INDESIT company

Model type:
AVXXF149DE

Commercial code:
F033722

n0508c01: Door Gasket Clamp Band

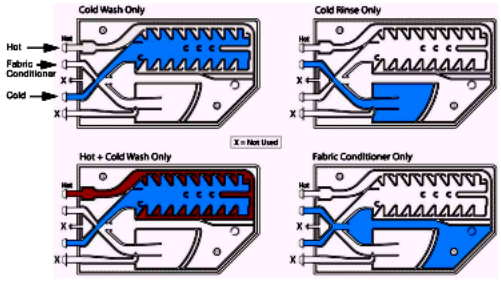
A New Polypropylene Gasket clamp band has been introduced in production from Serial number 80325.0000
The purpose is to provide added support to the inner rim of the door gasket.
